Work Order ID 74697

Item Name: Crosstube Turning Detail

DART AEROSPACE LTD	Work Order: 74697
Description: Crosstube Assembly (205/212 High Aft)	Part Number: D212-664-241
Inspection Dwg: D212-664-241 Rev: D	Page 1 of 1

DRAWING NO. D212-664-241	TITLE CROSSTUBE ASSY (205/212 HI AFT)	REV. D	DART AEROSPACE LTD ENGINEERING ORDER		D.E.O. NO. D212-664-241-D-1	SHEET NO. SHEET 1 OF 2	SCALE NTS
DRAWN	CHECKED	MFG. APPR.	APPROVED	DE APPR.			
DATE 11.04.07	DATE 11.04.11	DATE 11.04.12	DATE 11/04/12	DATE 11.04.12

**D212-664-241/-241B
ASSEMBLY DETAIL**

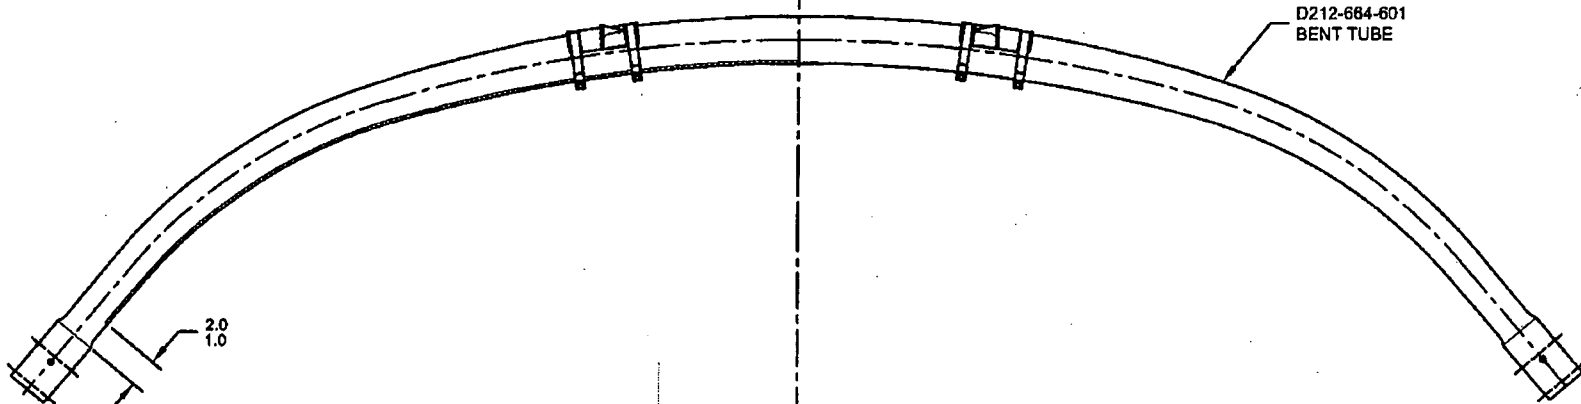
PURPOSE:

ADD AN INSPECTION WINDOW TO UNDERSIDE OF CROSSTUBE.

MASK AREA PRIOR TO PAINTING,
REMOVE MASKING AFTER PAINT
AND APPLY CLEAR COAT

- 2) FINISH: CHEMICAL CONVERSION COAT PER DART QSI 005 4.1
PRIME INSIDE AND OUTSIDE PER DART QSI 005 4.2
MASK UNDERSIDE OF CROSSTUBE AS SHOWN (HATCHED AREA) AND
PAINT OUTSIDE PER DART QSI 005 4.2
REMOVE MASKING AND APPLY CLEAR COAT
